# UNITED STATES PATENT AND TRADEMARK OFFICE

| APPLICATION NO.                                                                 | FILING DATE | FIRST NAMED INVENTOR | ATTORNEY DOCKET NO. | CONFIRMATION NO. |
|---------------------------------------------------------------------------------|-------------|----------------------|---------------------|------------------|
| 10/523,186                                                                      | 01/28/2005  | Iouri Kalinitchenko  | 02-38 US            | 8299             |

**Office Action Summary**

Fig.3

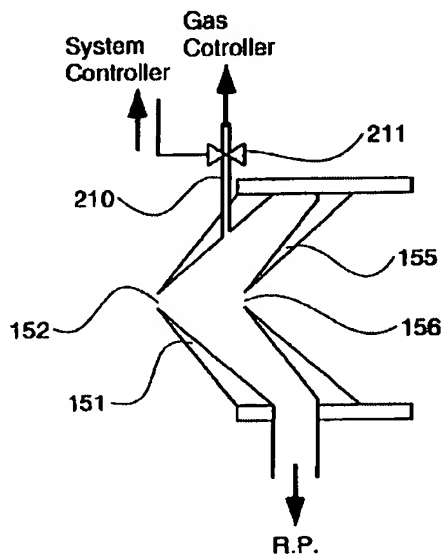
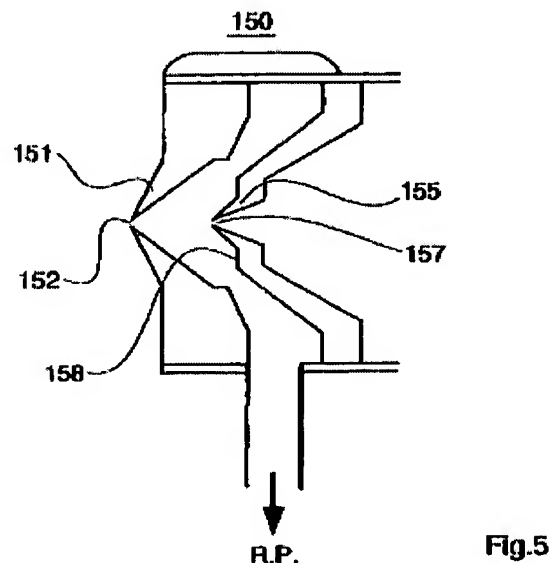
Sakata further teaches that an inlet 210 is fitted to the interface stage to enable the introduction of a gas (Note Figure 3 below). Introduction of gas (a substance) into the interface stage results in an increase of pressure, which increases ion collisions, and again dissociating the polyatomic ion species that give rise to spectral interferences. Col. 5, line 46-64.

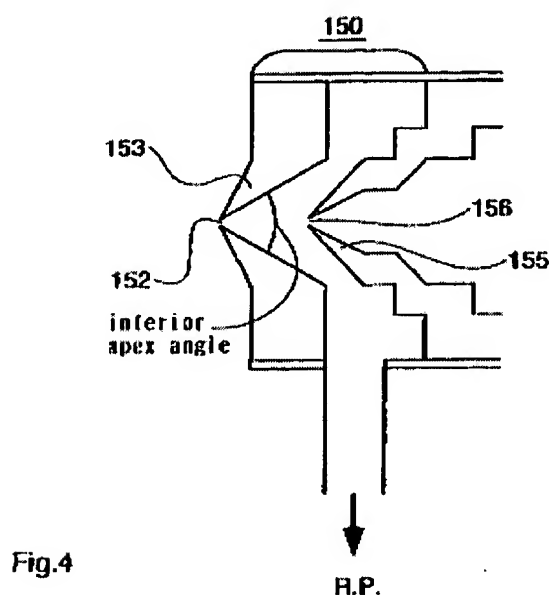
7. Regarding claims 9-11, Sakata teaches modifying the sampling cone, by narrowing the interior apex (Note Figures 4 and 5 below) to reduce the pumping efficiency behind the sampling orifice, leading to increased pressure in the region between the cone orifices. It should be noted in Figure 4 that the interface stage has parallel walls, and narrowing the apex angle makes the sampling cone longer.
